**Remarks**

The Office Action mailed December 23, 2005 has been carefully reviewed and the foregoing amendment has been made in consequence thereof.

FIG. 3

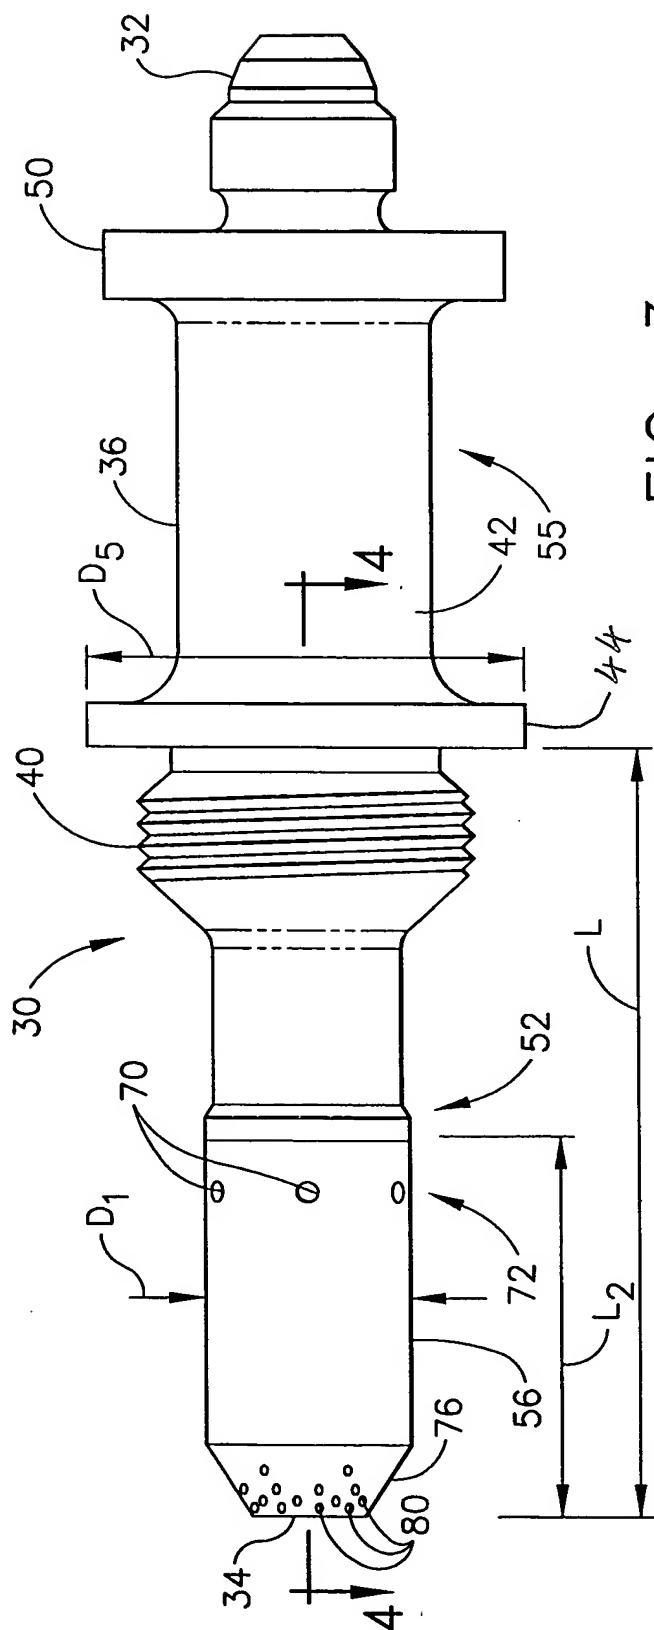
The objection to the drawings is respectfully traversed. Specifically, Figure 3 has been amended to identify an annular shoulder described in the specification at paragraph [0016], for example, and given reference number 44. Applicants hereby submit a "Replacement Sheet" incorporating the change to Figure 3. No new matter has been added. Accordingly, for at least the reasons set forth above, Applicants respectfully request the objection to the drawings be withdrawn.

Applicants respectfully request approval of the following drawing change. Specifically, Reference number 44 has been added to Figure 3 to identify an annular shoulder extending radially outward from body 36 as set forth in the Specification, for example, at paragraph [0016]. Applicants hereby submit a "Replacement Sheet" incorporating the change to Figure 3. No new matter has been added.
